**DESIGN-BUILD PROJECT
CNN-11007, FACILITY
REPAIRS AND MODS TO
BLDG 150, MCAS
CHERRY POINT NC
AMENDMENT #0004**

14. DESCRIPTION OF AMENDMENT/MODIFICATION (Organized by UCF section headings, including solicitation/contract subject matter where feasible.)
DESIGN-BUILD PROJECT CNN-11007, FACILITY REPAIRS AND MODIFICATIONS TO BLDG 150 , MARINE CORPS AIR STATION, CHERRY POINT, NORTH CAROLINA

OVER HEAD CRANE CLEARANCE WORKSHEET

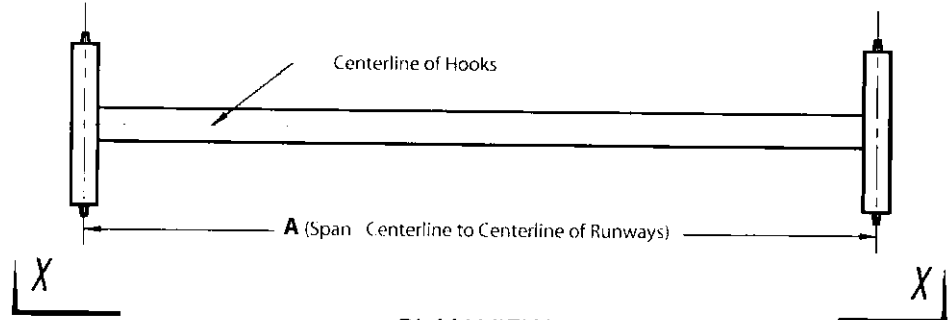
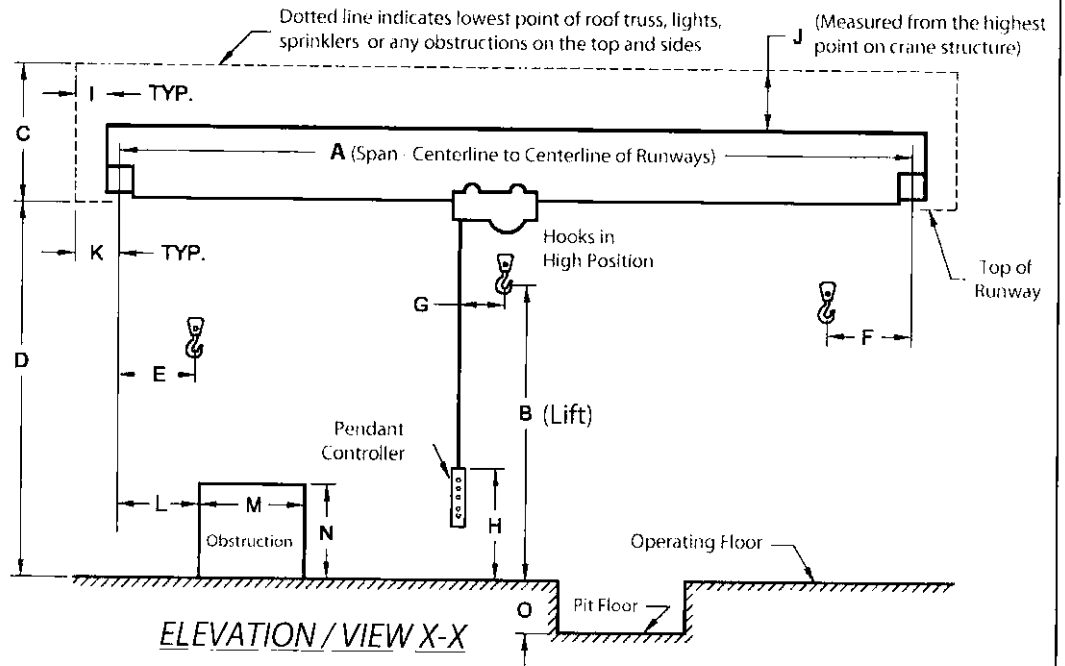
QUESTION 2: Scope of Work - Item B. Civil - # 4; Install a free standing five ton bridge crane in the high-bay area of Bay "F". Is there a required distance that the bridge crane is suppose to span for Bay "F"?

ANSWER 2: Please see the attached Crane Information Form.

- A: 26'-0"
- B: 15'-0" min.
- C: _____
- D: _____
- E: 2'-0" max.
- F: 2'-0" max.
- G: _____
- H: 3'-0" ref.
- I: 2" min.
- J: 3" min.
- K: 2'-0" (smallest)
- L: n/a
- M: n/a
- N: n/a
- O: n/a
- P: n/a
